Mobile Pentium® II Processor Specification Update

Release Date: July 1999

Order Number: 243887-012

The Mobile Pentium® II processor or the Intel® Pentium® II Processor Mobile Module may contain design defects or errors known as errata which may cause the product to deviate from published specifications. Current characterized errata are documented in this Specification Update.

Old Mobile Pentium® II Processor in Mini-Cartridge Package Label with Supplier Matrix Mark

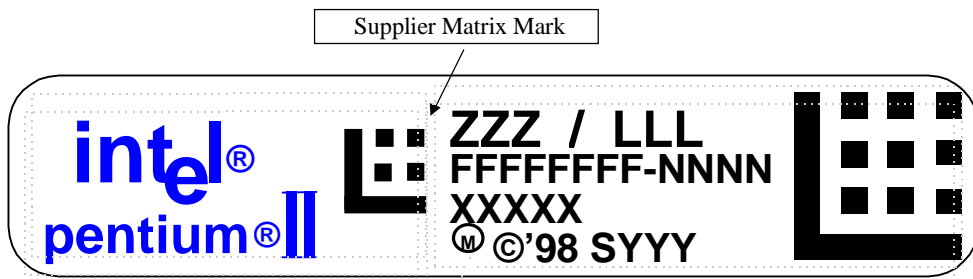
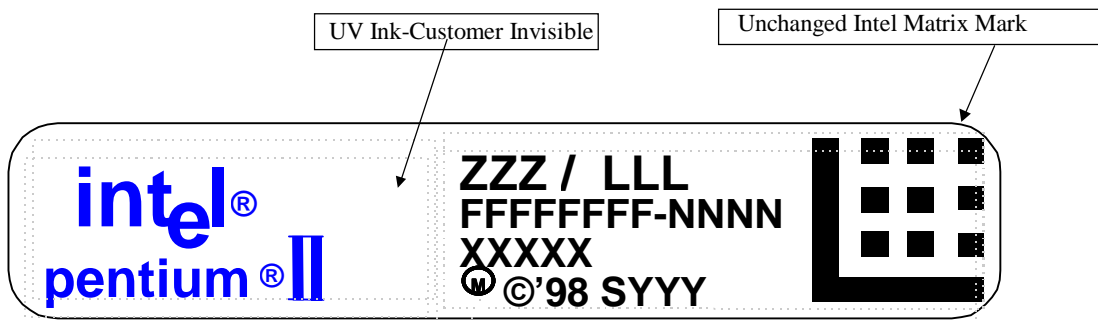
New Mobile Pentium® II Processor in Mini-Cartridge Package Label with Supplier Matrix Mark Removed

Figure 5.6. Cross Sectional View with Vertical Dimensions

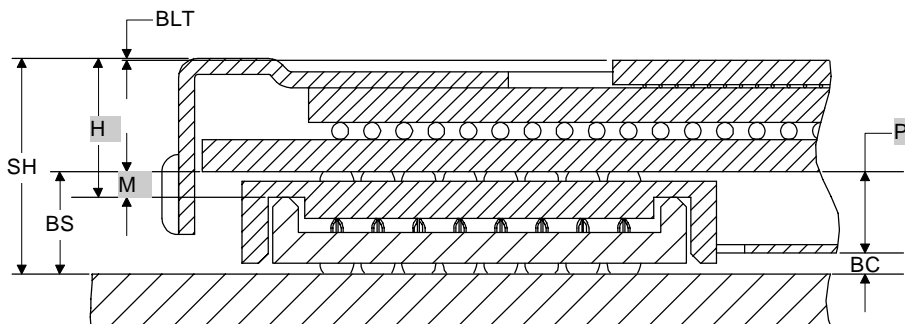
B1. Misabeled Vertical Dimension Parameters

Figure 5.6 in the *Mobile Pentium® II Processor at 233 MHz, 266 MHz, and 300 MHz* datasheet should be replaced by the following figure:

Figure 5.3. Surface-Mount BGA1 Package—Top and Side View

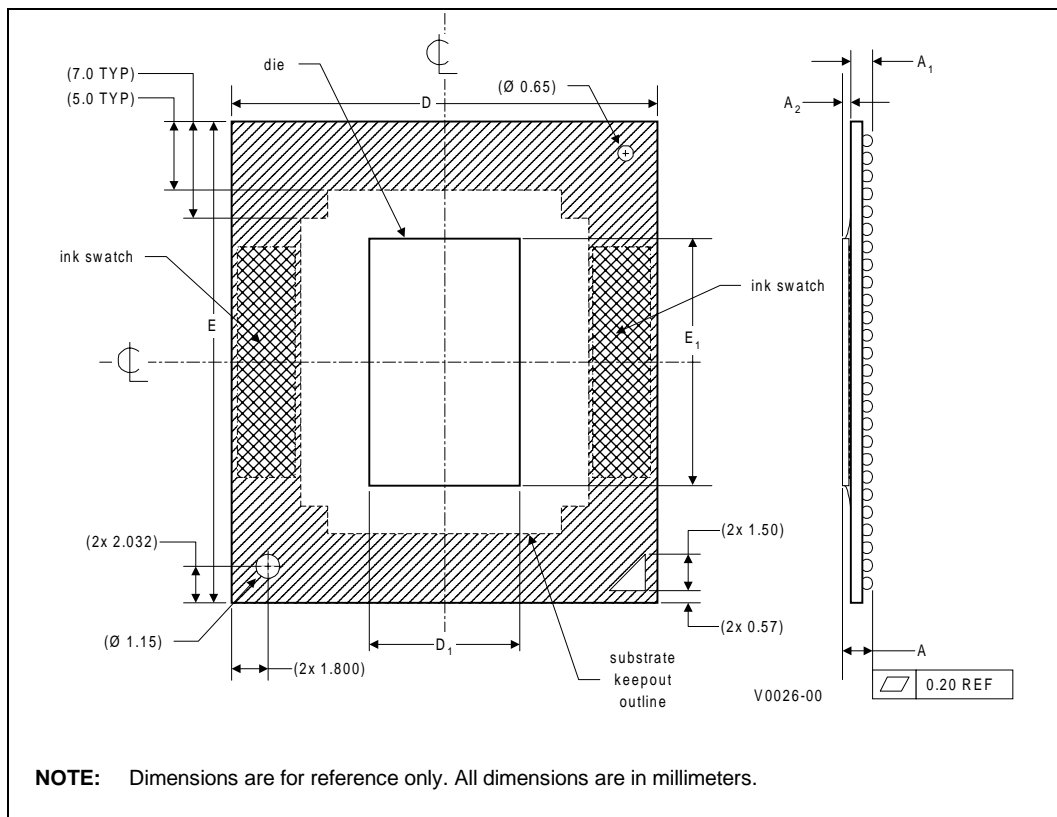
The following table and figures show the updated mechanical specifications for the BGA1 package, listed as Table 5.2, Figure 5.3 and Figure 5.4, respectively, in the *Mobile Pentium® II Processor in BGA Package at 366 MHz, 333 MHz, 300PE MHz, and 266PE MHz* datasheet.

Figure 3.3 Generic Clock Waveform

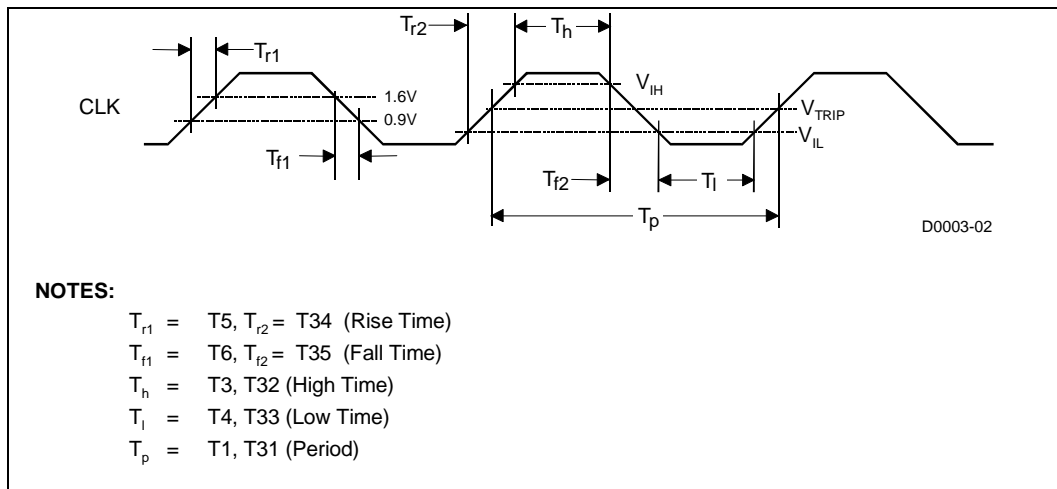
B14. Generic Clock Waveform Figure

Figure 3.3 in *Mobile Pentium® II Processor in Mini-Cartridge Package at 366 MHz, 333 MHz, 300PE MHz, and 266PE MHz* datasheet (Order Number 245108), and the *Mobile Pentium® II Processor in BGA Package at 366 MHz, 333 MHz, 300PE MHz, and 266PE MHz* datasheet (Order Number 245106) has been updated. The following figure is to replace the ones in the above documents.

Figure 1. TAP Gageable Thread Clarification

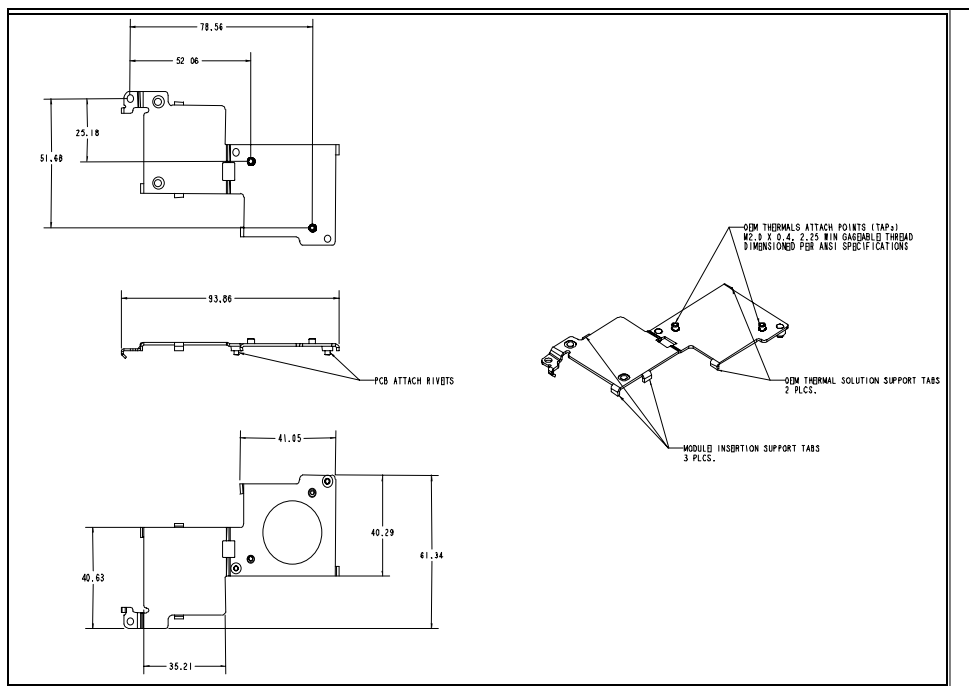
In the *Intel® Pentium® II Processor Mobile Module : Mobile Module Connector 1 (MMC-1)* and the *Intel® Pentium® II Processor Mobile Module : Mobile Module Connector 2 (MMC-2)* datasheets (Order Numbers 243667 and 243668, respectively), the thermal attach point (TAP) gageable thread specification was not clearly identified in Figure 14, of Section 5.2. The following is the TAP clarification:

OEM Thermal Attach Points (TAPs) M2.0 x 0.4, 2.25 min gageable thread dimensioned per ANSI specification.

See Figure 1 below for more information.
